**SOUTHERN CALIFORNIA EDISON
KERN RIVER NO. 3 HYDROPROJECT**

DOCKET NO. P-2290-122

**KERN RIVER BOATERS' COMMENTS, STUDY
REQUESTS, AND INFORMATION REQUESTS IN
RESPONSE TO PRELIMINARY APPLICATION
DOCUMENT AND SCOPING DOCUMENT ONE**

Figure 53: South Fork American v. NFKR Rec Flow Schedules

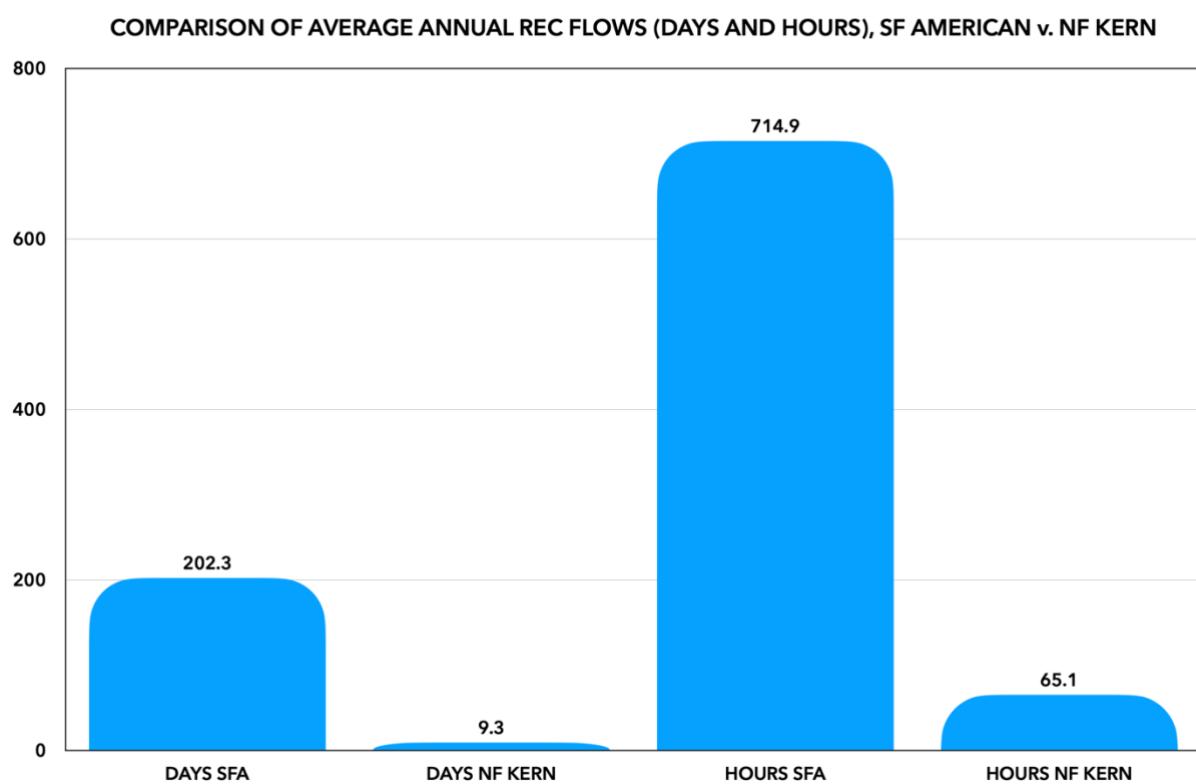
We believe it is salient to compare the rec flow schedule for the dewatered reach of the NFKR with that of the South Fork American. Unlike Fairview Dam, the Chili Bar reservoir on the has significant storage, and releases between 1,300 and 1,500 cfs of that storage (compared to the average of 150 additional cfs on the NFKR) for three to five hours on rec days.¹¹⁵ Notwithstanding the storage difference of the two systems — which we attempt to account for by not looking at comparative quantities of cfs provided, a number which would show an even greater disparity — the number of days and hours involved in the Chili Bar rec schedule demonstrates both contemporary social expectations for whitewater recreation and the amount of hydropower disruption tolerated to meet those expectations:

Figure 56: Median NFKR Flows, 1997-2020

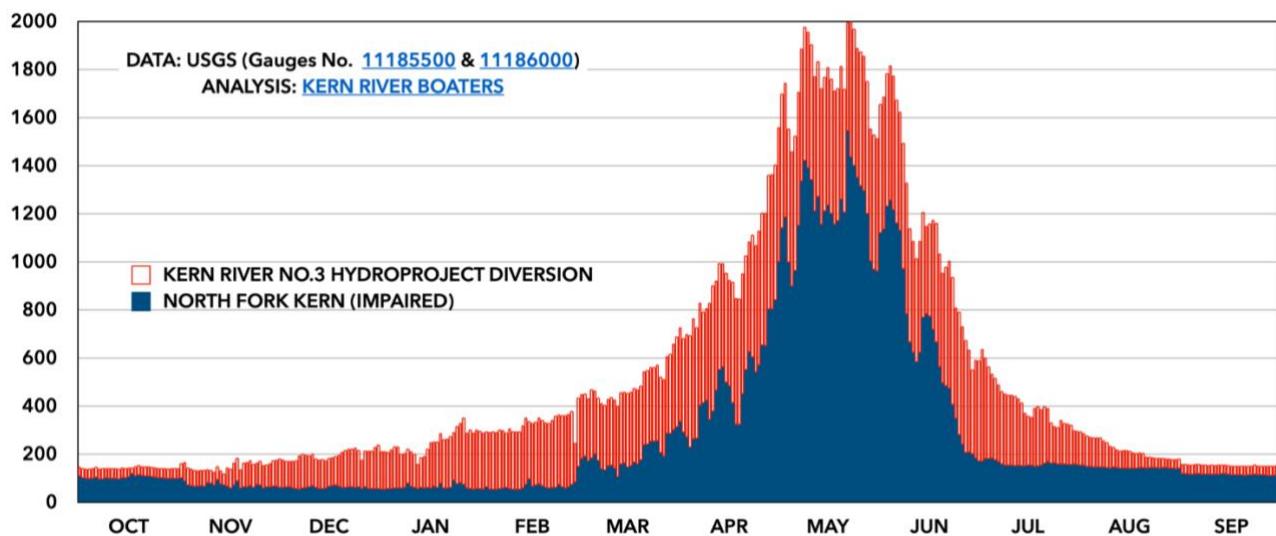
After the minimum instream flow is satisfied, the project takes the next 600 cfs. That leaves the dewatered reach at a flat-lined fish flows for two-thirds of the year:
